03 - 2010  
HP2050/ HP2050H  
3/4" 2-SPEED HAMMER DRILL

**SERVICE CHANGES**

**2. Changes on Gear Com. and O Ring**

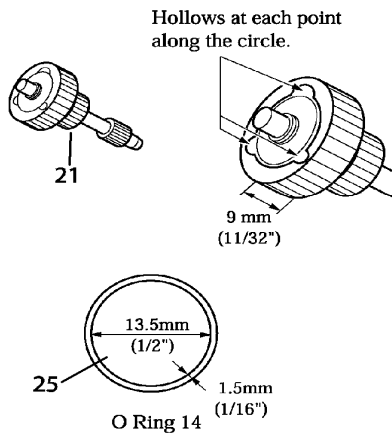
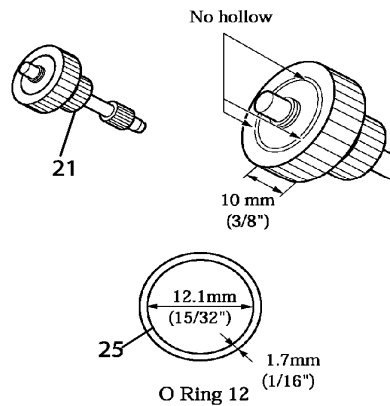
Item No.	Description	Type 1	Type 2
21	Gear Com.	153363-4 (N/L/A)	153622-6
25	O Ring	213162-7	213122-9
-	Grease N No.1 # 042017-7A	(use 38.5g)	(use 30.0g)

Above parts are completely interchangeable as a set.

**3. Addition of Adhesive and Modification of Gear Housing Cover Com.**

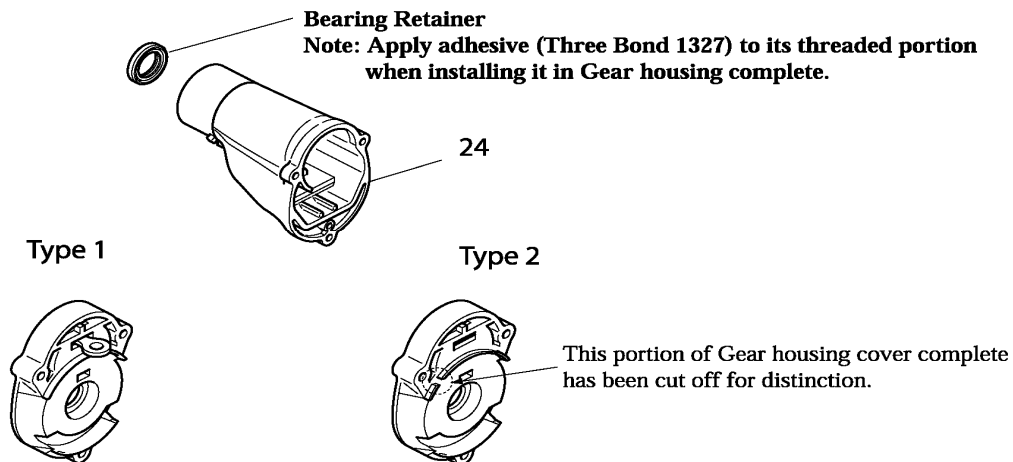
Item No.	Description	Type 1	Type 2
24	Gear Hsg Cover	153364-2 (N/L/A)	153620-0
